Subject: River Bend Station - Unit I  
Docket No. 50-458  
License No. NPF-47  
Final Requests for Relief from ASME Code Section XI Inservice Inspection  
Requirements for the First Ten-Year Inspection Interval

## SUMMARY OF CHANGES TO REQUESTS FOR RELIEF

REV.: 1		DATE: 2-17-86	DRAWN: CAG	CHK'D: JWL	DWG. NO. RBS-ISI-033	VENT & HEAD SPRAY ASSY.
					APPR.: SPS	DATE: 11/30/98
						WELD MAP

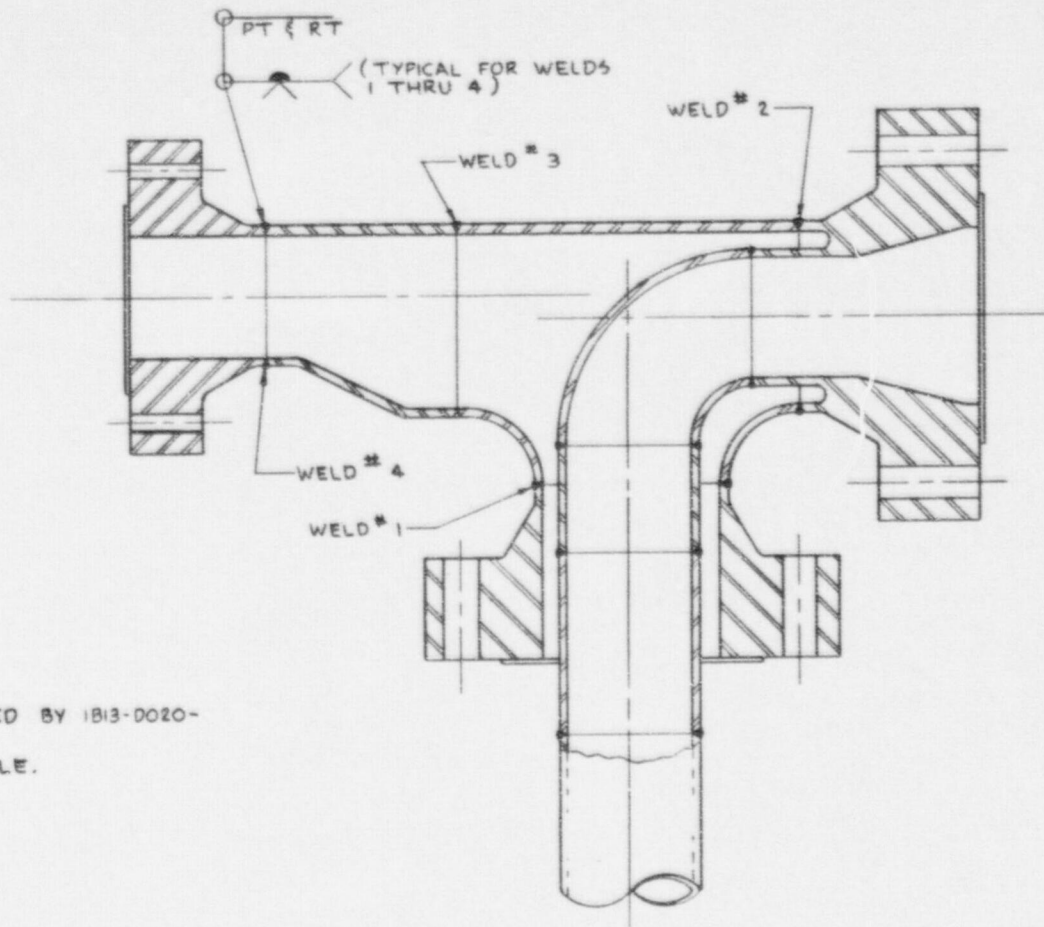
Due to the component configuration (see attached sketches), there is not a sufficient examination surface to perform a meaningful code required Volumetric (ultrasonic) examination. Only certain percentages, if any, can be obtained.

The component-to-component weld configuration causes some, if not all areas of examination to be made inaccessible for ultrasonic transducers to be placed in appropriate location. If welds require a mandatory selection for examination, then accessible areas will receive an ultrasonic examination and the entire weld will receive a Surface examination. Coverage percentages will be documented on the examination reports.

1	2-19-86	NEW ISSUE	CAG	JWL	JBB	5/29/86	LINE 1-IC5-006-057-1 FROM DRYWELL TO UPPER FUEL POOL - PIPE TO FLANGE
REV	DATE	DESCRIPTION	DRWN	CHK'D	APPR.	DATE	DWG. NO. RB5-151-034

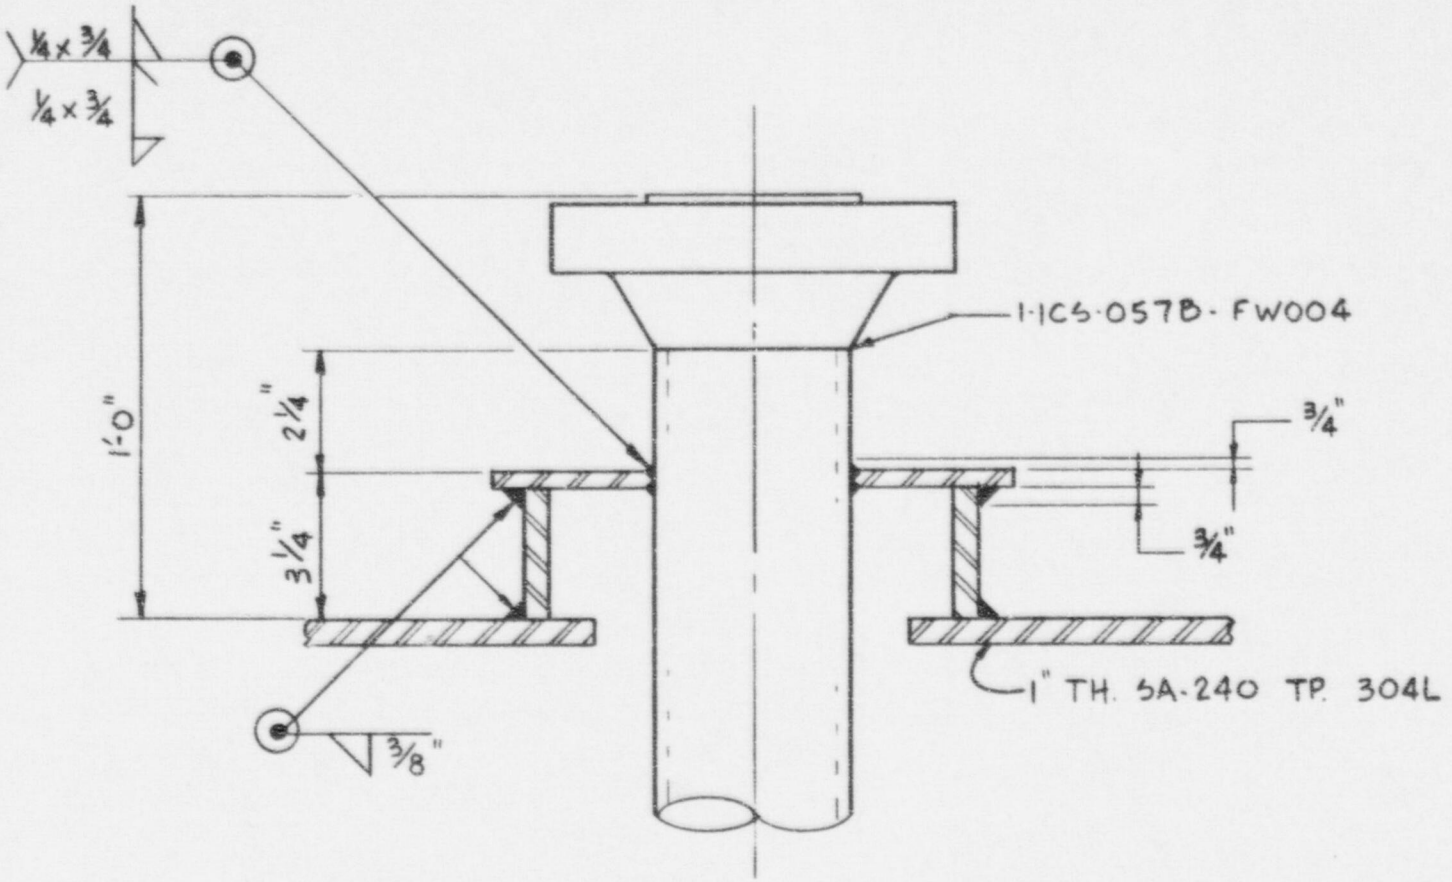
Line No.	Mark Number	Configuration	%Exam	Sketch
006-057-1	ICS057B-FW004	Pipe-to-Flange	0	2

1	2-19-84	NEW ISSUE	CAG	JwL	JBB	5/29/86	SWEEP-O-LET TO FLANGE
REV	DATE	DESCRIPTION	DRWN	CHK'D	APPR.	DATE

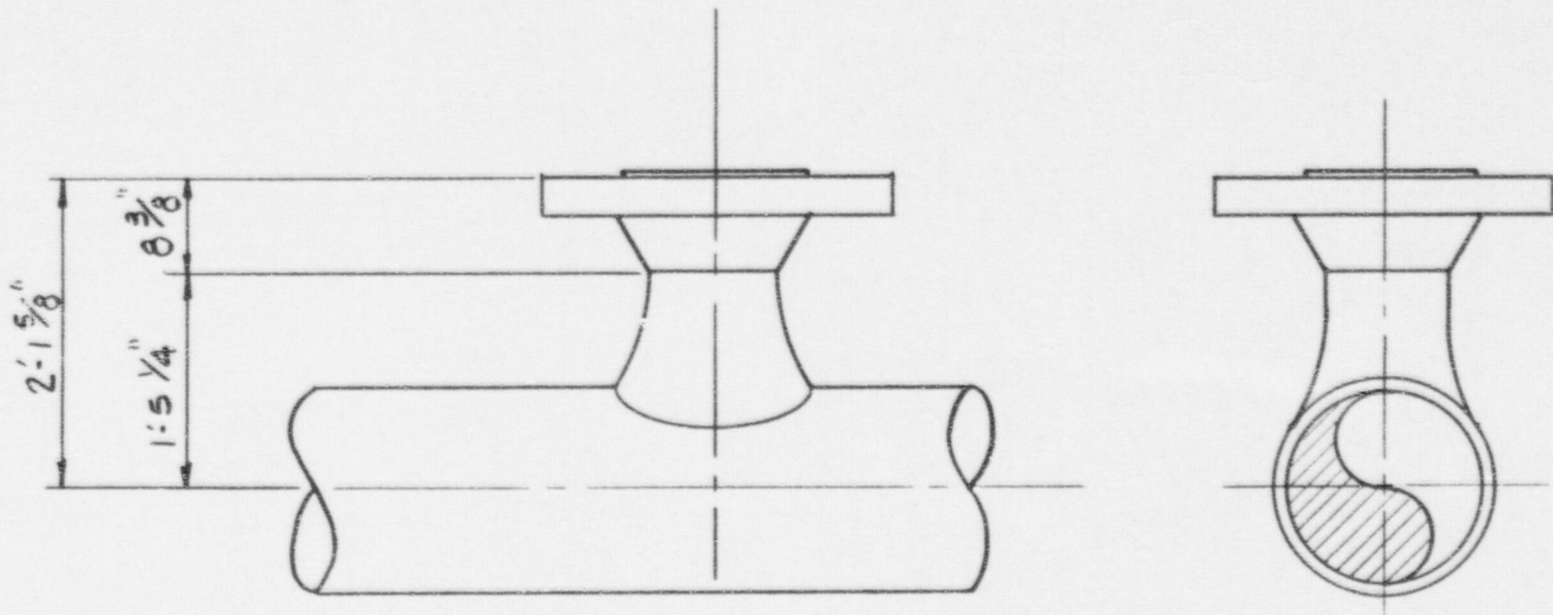
Line No.	Mark Number	Configuration	%Exam	Sketch
024-600-1	MSS600A2-SW05E	Sweepolet-to-Flange	0	3
024-600-1	MSS600A2-SW05F	Sweepolet-to-Flange	0	3
024-700-1	MSS700A2-SW08H	Sweepolet-to-Flange	0	3
024-700-1	MSS700A2-SW08J	Sweepolet-to-Flange	0	3
024-700-1	MSS700A2-SW08K	Sweepolet-to-Flange	0	3
024-700-1	MSS700A2-SW08L	Sweepolet-to-Flange	0	3
024-700-1	MSS700A2-SW08M	Sweepolet-to-Flange	0	3
024-800-1	MSS800A2-SW07J	Sweepolet-to-Flange	0	3
024-800-1	MSS800A2-SW07K	Sweepolet-to-Flange	0	3
024-800-1	MSS800A2-SW07L	Sweepolet-to-Flange	0	3
024-800-1	MSS800A2-SW07M	Sweepolet-to-Flange	0	3
024-800-1	MSS800A2-SW07N	Sweepolet-to-Flange	0	3
024-800-1	MSS800A2-SW07P	Sweepolet-to-Flange	0	3
024-900-1	MSS900A2-SW06F	Sweepolet-to-Flange	0	3
024-900-1	MSS900A2-SW06G	Sweepolet-to-Flange	0	3
024-900-1	MSS900A2-SW06H	Sweepolet-to-Flange	0	3

REV: 1	DATE: 5-13-85	DRAWN: CAG	CHK'D: J.S.W.	APPR: JBR	DATE: 11-30-98	DWG. NO. RBS-ISI-004 I-CSH-1-E22*PC001 WELD MAP DISCHARGE HEAD & SUCTION BARREL
--------	---------------	------------	---------------	-----------	----------------	---

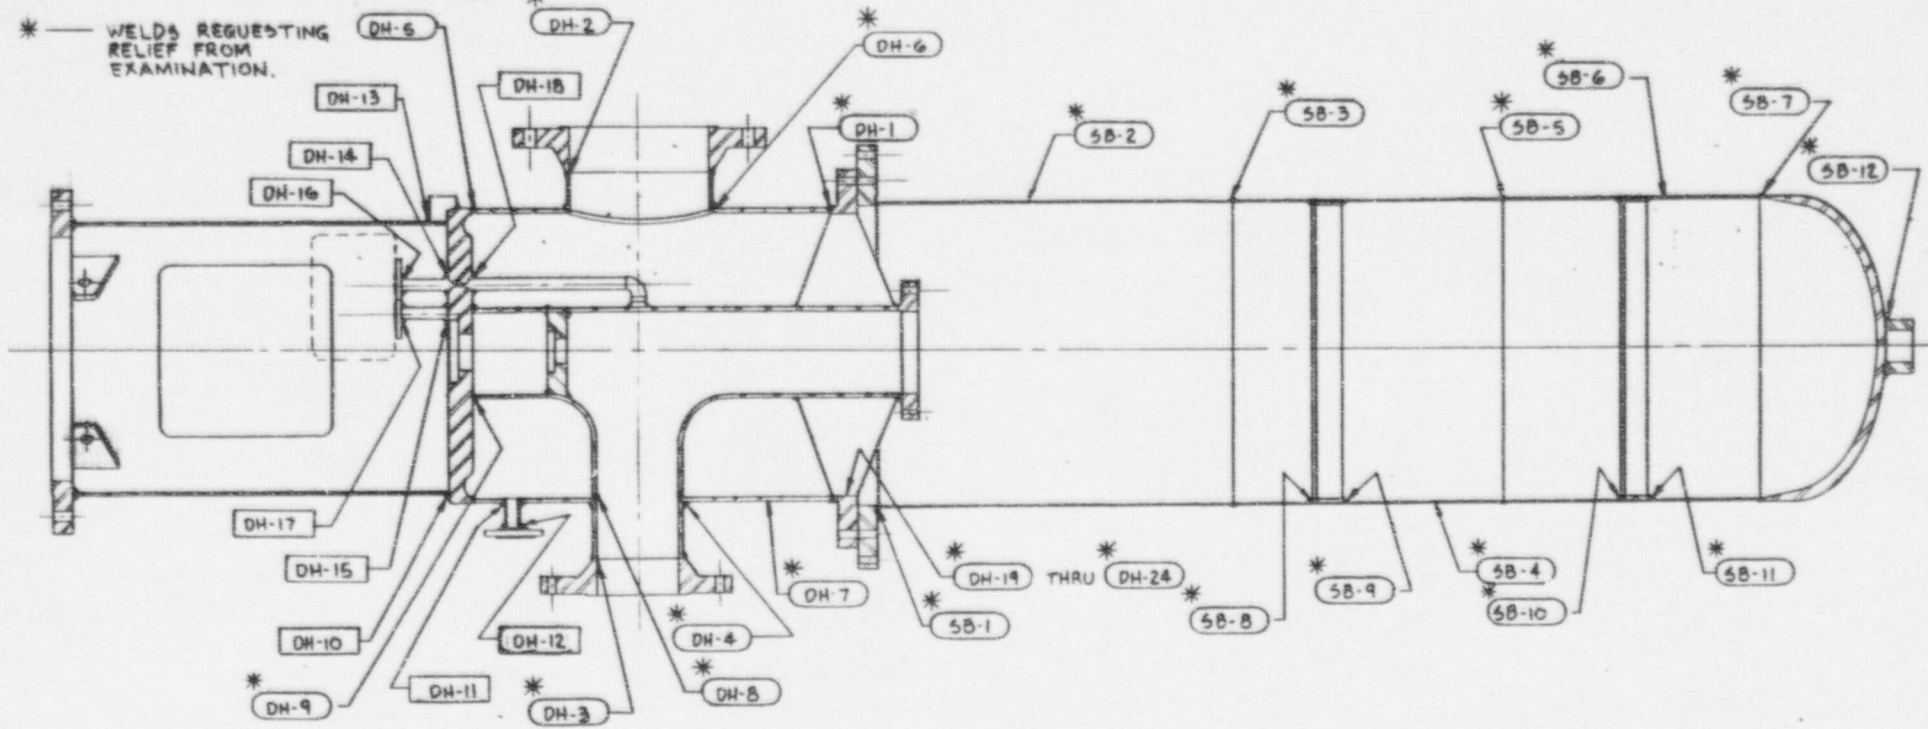
1. Updated mark numbers to current format
2. Changed examination percentages for each DH-1 weld from 10 to 0 %. The original percentage was an estimate based on preservice inspection PT data. Pump bolting configuration prevents access to weld for PT prep or performance of MT examination.

Due to close proximity of adjacent structures, there is no access to welds located behind flanges (bolting interference) and welds located behind "RHS" pump heat exchangers. Pump casing welds are inaccessible due to concrete encasement. Examination of required welds would require complete disassembly of pumps. If the pump is disassembled for normal maintenance, examination of welds will be performed at that time.

1	2-20-86	NEW ISSUE	CAG	JWL	JBB	5/29/86	PIPE TO PUMP	
REV.	DATE	DESCRIPTION	DRWN	CHK'D	APPR.	DATE	DWG. NO.	RB 5 - ISI - 049

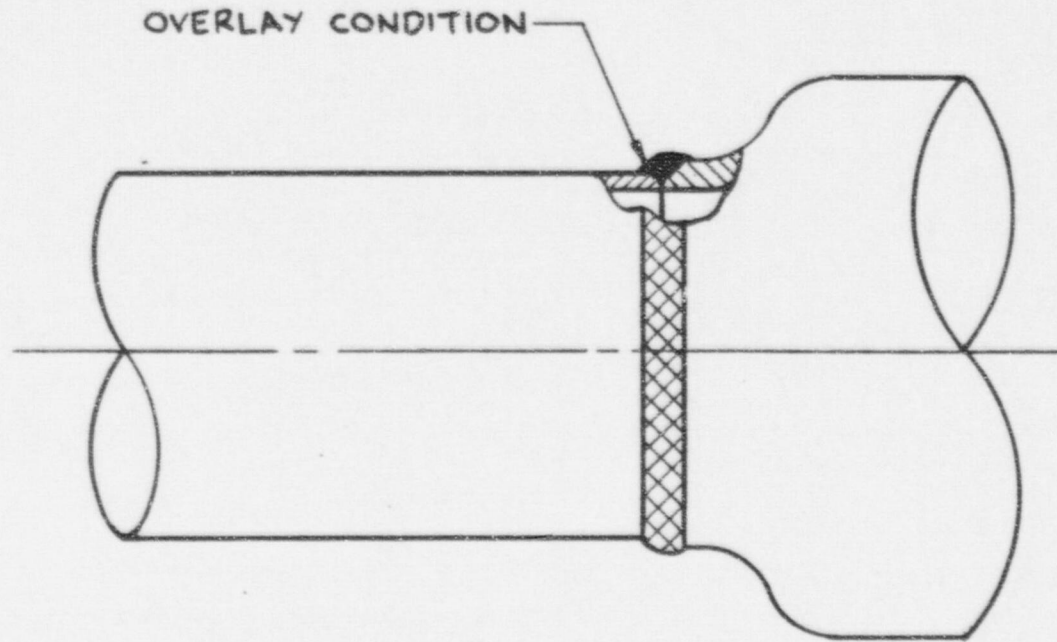
Revised examination percentages for RCS800B welds FWA06, FWA07, FWA08, FWA09, and FWA10 from 50 to 40 %. The original percentage was an estimate based on preservice inspection data. The actual coverage calculations are based on examination technique used and configuration limitations present.

- A) Due to component weld configuration, the code required volumetric examination can only be performed by Ultrasonic Testing using the V and 1/2 technique from one side of the weld area.
- E) Due to weld overlay conditions and using the V and 1/2 technique, a 100% code required examination is not obtainable in the weld exam area.
  - 1) Thickness of pipe plus thickness of overlay and configuration of overlay in weld area.
  - 2) Attenuation of sound waves through overlay thickness, through pipe wall thickness and varying weld configuration.

RADIATION SHIELDING PLUG INTERFERENCE  
DWG NO. RB5-151-124

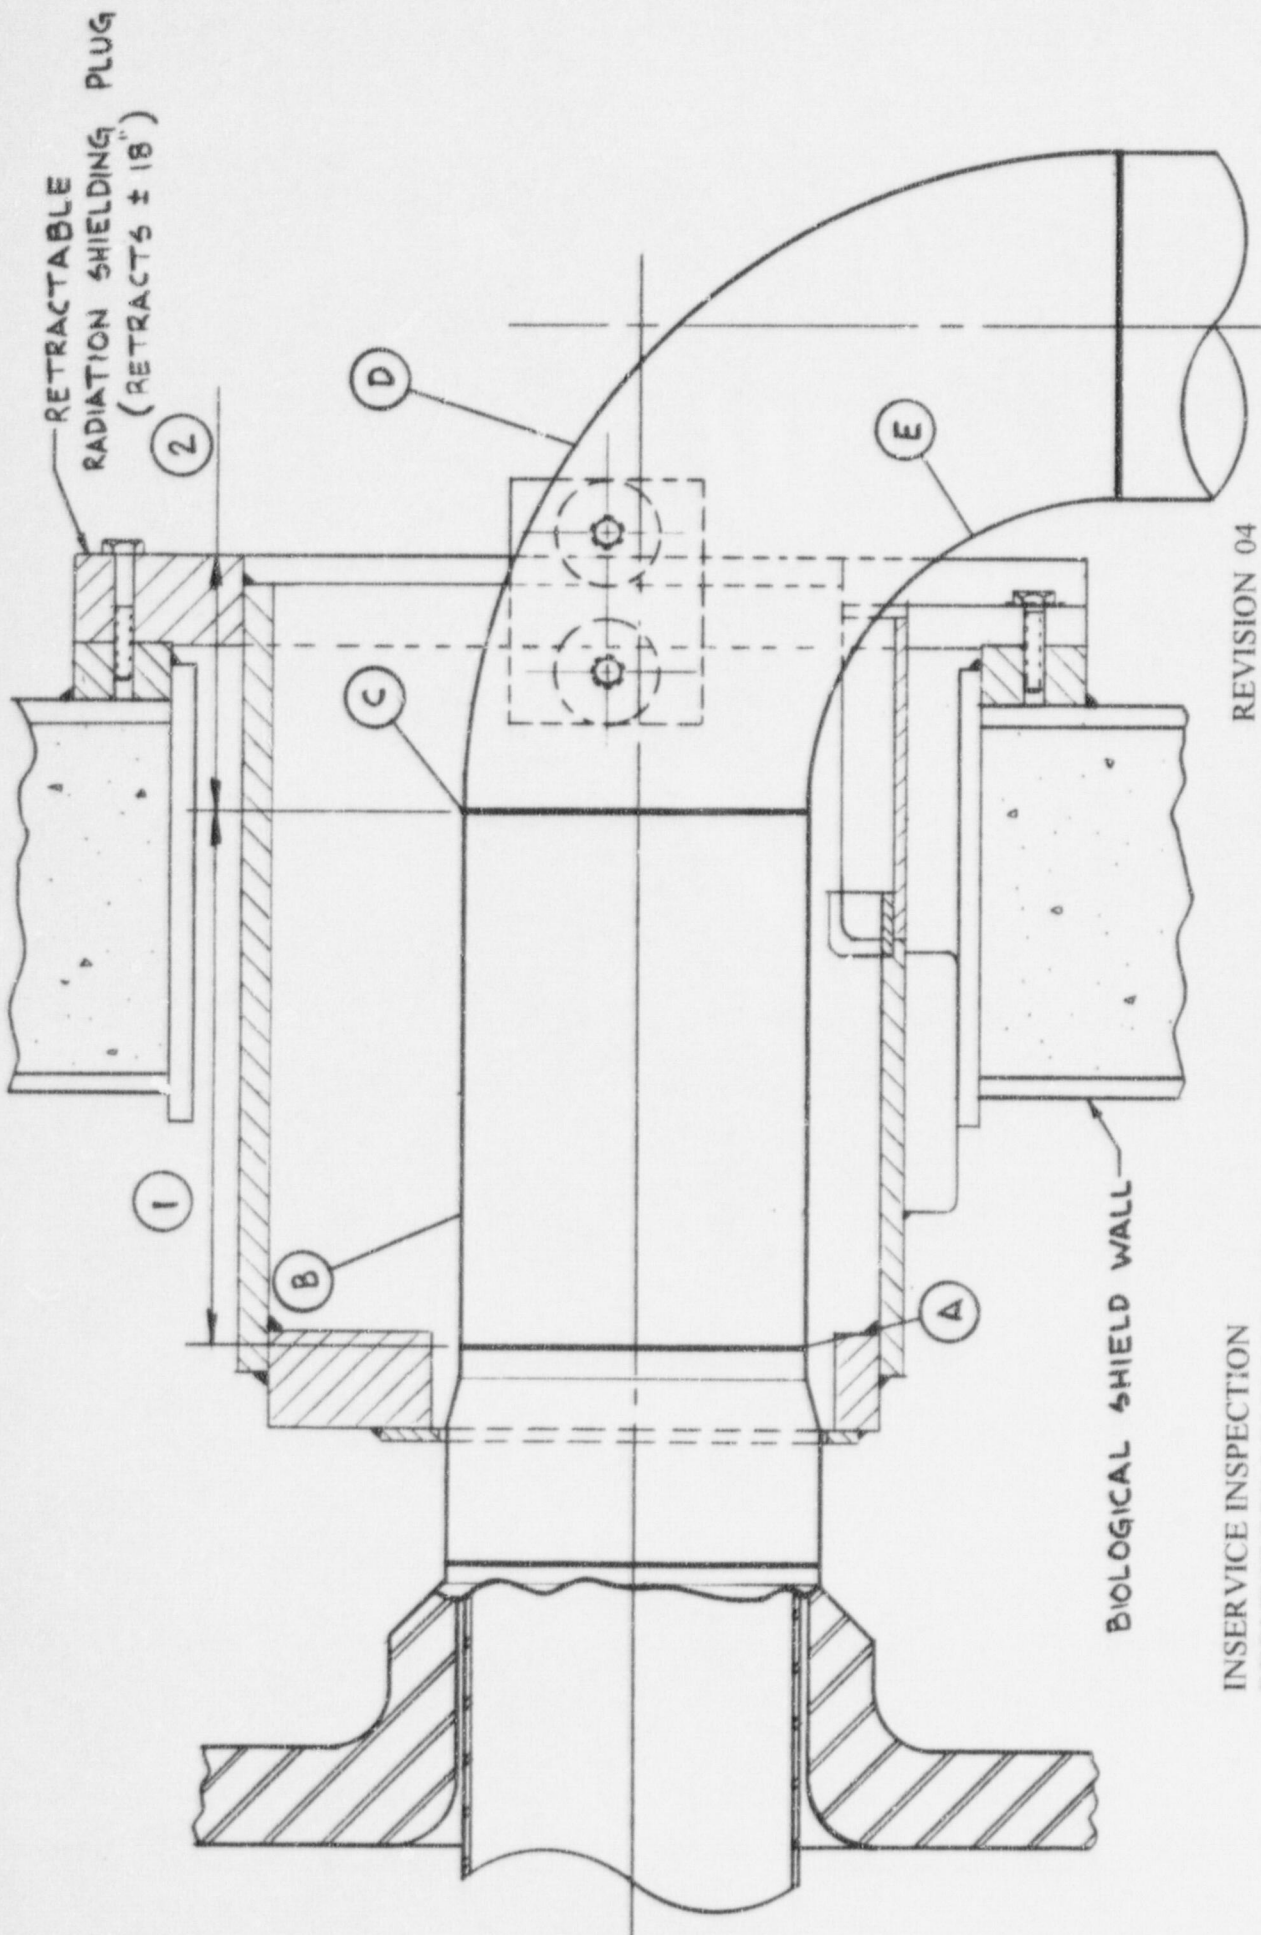
Revised examination percentages for welds RCS900C-SW023ALC and RCS900C-SW024ALC from 30 to 25 %. The original percentage was an estimate based on preservice inspection data, and the new percentages are due to actual length of weld examined.

Due to the installation of radiation shielding plugs the required area of examination cannot be examined. The accessible portion of the weld will be examined in accordance with Section XI requirements.

INSERVICE INSPECTION  
REQUEST FOR RELIEF RRI1-0017

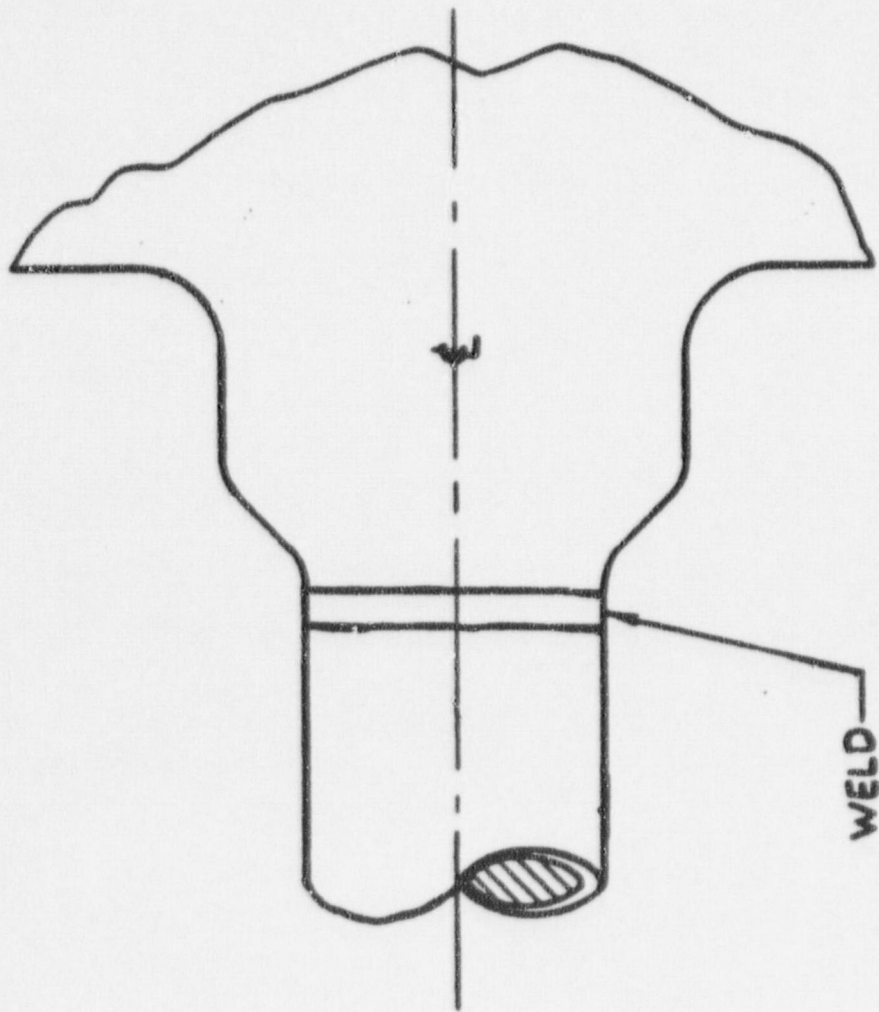
This new request for relief reflects the limitations posed by the nozzle-to-safe end configuration and the associated examination percentages obtained for B13-D001 welds N01A-2, N01B-2, N2A-2, N2B-2, N2C-2, N2D-2, N2E-2, N2F-2, N2G-2, N2H-2, N2J-2, N2K-2, N4B-2, N4C-2, N4D-2, N5A-2, N5B-2, N6A-2, N6B-2, N6C-2, N9A-2, and N9B-2.

The nozzle configuration does not permit performance of 100% of the Code required volumetric examination. The profile of the vessel nozzle limits examination from the nozzle side of the weld.
